From:	Kaan Dilber
To:	Danny Mapili - WPD-C
Cc:	Joshua Hill; Terry Lamb Sr.; Todd Williams; Patrick J. Murray; Edwin Lopacki - WPIB; Andrea Mango
Subject:	RE: FERC Swing: Status of Design Review
Date:	Tuesday, July 19, 2016 4:55:24 PM
Attachments:	image001.png OTJ IT and Equipment Questionnaire - FERC response.docx RE FERC Swing Meeting .msg

Good morning Josh,
I would like to check the status of the Design Review for the 100%CD's FERC Swing.

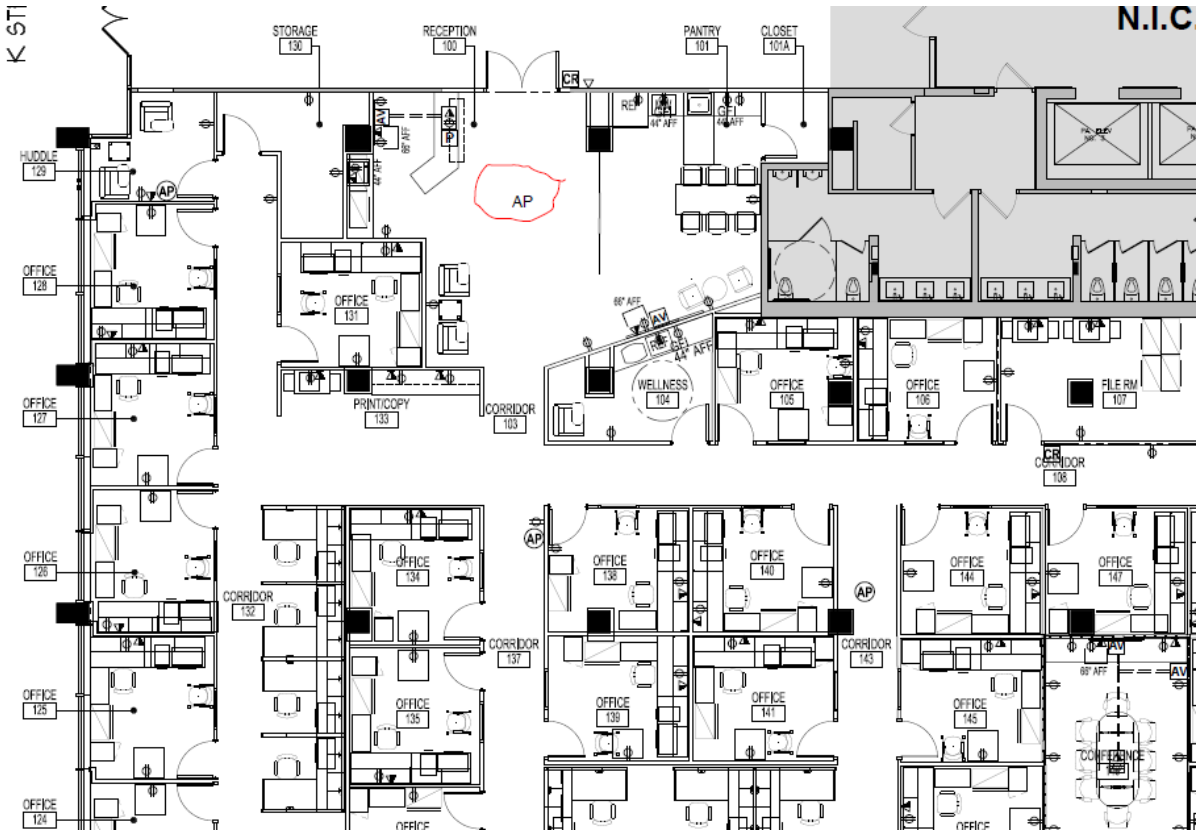
On A301, we may need an additional wireless access point located in the vicinity of the entrance to the suite (see drawing below).

Also, I do not see where the low-voltage cabling is included anywhere, either in the drawings or specifications. We had discussed this being included in the construction work.

Please let us know what information you want us to incorporate into the CDs. Can you please provide FERC's low voltage requirements/specifications so cabling vendors will be able to provide their proposal through Akridge/CIM?

Also, please note that the power and signal plans in the permit set were put together based on the attached power and data requirements provided by FERC.
